# **Planning Commission Memorandum**

Item: Tabled - OHDS review for a detached garage & Variance for driveway- #2012-41 – 408

Ashland Street – Blake and Rebecca Kiernan

**Original Plan**

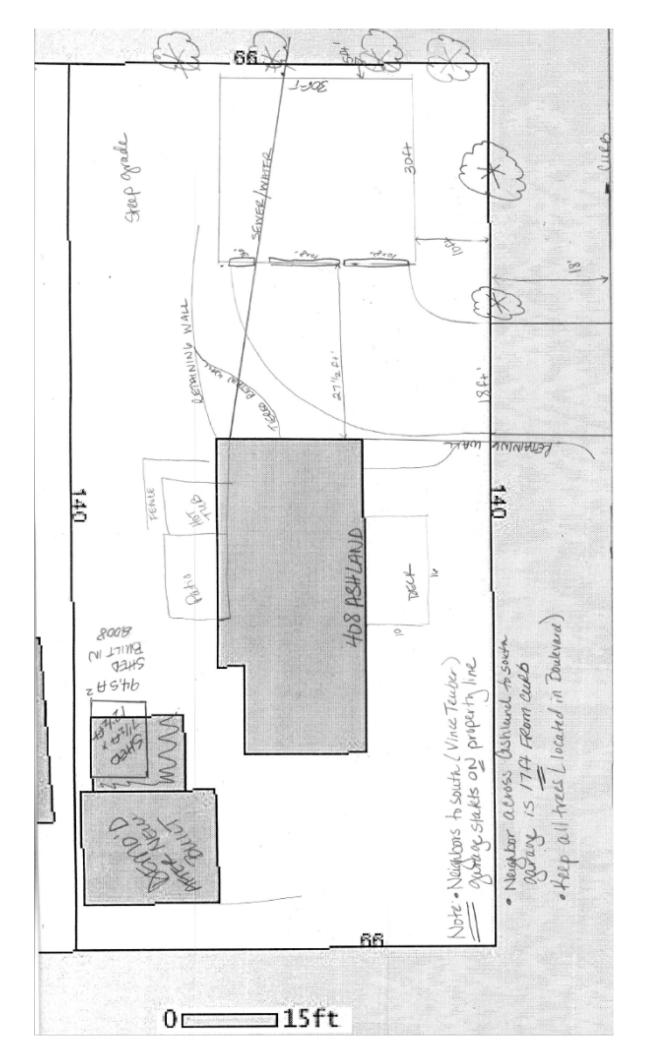
**Updates to report:** As shown on the revised site plan, the size of the garage has been reduced from 38' X 26' (988 Sq Ft) to 30'X30' (900 Sq Ft). This will allow them to keep the garden shed (94.5 Sq Ft) on the property.

The required side setback is 10-feet from the property line. The applicants are proposing a 5-foot setback. The applicants state this is due to needing room to turn vehicles into the side-loaded garage.

There is not a definitive amount of space needed for this. The plan shows a 27.5' turn around area to the retaining wall and house. The parking lot standards for a 2-way drive isle to pull into a 90-degree parking stall is only 22-feet.

One possible way to address this issue is to make the following changes, or similar variation:

- move the building 1-foot to the south (towards house)
- Reduce the building depth 4-feet from the north property line to 26' deep (the originally proposed depth)
- and increase the width of the building 5' to the west for a total width of 35'

Staff suggestions to comply with side setback
